**City of Bellevue  
Development Services Department  
Land Use Staff Report**

**Proposal Name:** Engleson Short Plat

**Proposal Description:** Preliminary Short Plat approval to subdivide an existing parcel into two single family lots within the R-3.5 zoning district.

**File Number:** 15-119035-LN

**Figure 1 – Preliminary Short Plat Proposal**

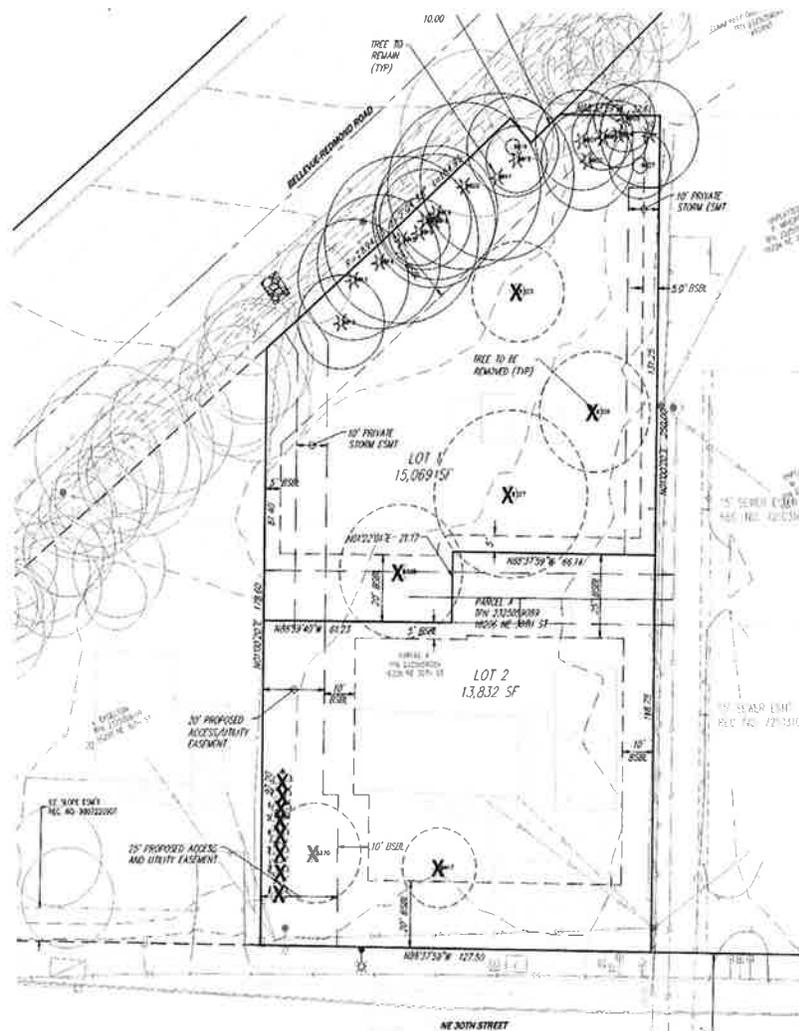
Access to Lots 1 and 2 will be from a private road off of NE 30th Street as shown on the approved plans. The adjacent single family lot to the west will also use this same private road for access to NE 30th Street. No other access connection to city right-of-way is authorized. The existing driveway located on the southeast corner of Lot 2 will not be permitted to remain and shall be removed. Street frontage improvements shall be provided at the location of the removed driveway and shall match the existing frontage and neighborhood character.

The joint use driveway serving Lot 1 shall be allowed to reduce the pavement width to a minimum of ten feet as shown on the approved plans and be located within an access easement that is twenty feet wide. The private road serving Lot 1, Lot 2, and the adjacent single family lot to the west shall have a minimum pavement width of twenty feet and be located within an access easement that is a minimum of twenty-five feet wide. The driveway approach shall be built per the City's Transportation Department Design Manual Standard Drawing DEV-7A. The private road name and site addresses will be determined by the City's Parcel and Address Coordinator Jami Carter, [jcarter@bellevuewa.gov](mailto:jcarter@bellevuewa.gov). Installation of a road name sign as per the City of Bellevue standards is required at the entrance to the private road. The signing will consist of one sign blade, sign post, and hardware.

- I. The construction of the private road for Lots #1, #2, and the adjacent single family lot to the west requires a minimum pavement width of twenty feet and a minimum access easement width of twenty-five feet. After the private road serves the adjacent single family lot to the west and Lot #2, the pavement width and access easement width may be reduced. The pavement width may be reduced to a minimum of ten feet and the access easement width may be reduced to a minimum of twenty feet.

- II. Delineate and dimension access easements.
- III. The existing driveway on the southeast corner of the property shall be removed.
- IV. Street frontage improvements matching adjacent improvements must be provided at the location of the removed driveway. This includes installation of concrete curb and gutter, a planter strip, landscaping, and concrete sidewalk.

- IX. Installation of a private road sign, sign post, and hardware.
- X. Installation of a street light at the intersection of the proposed private road to the public road NE 30th St is required. The street light shall be mounted on a round concrete pole with an underground power feed.
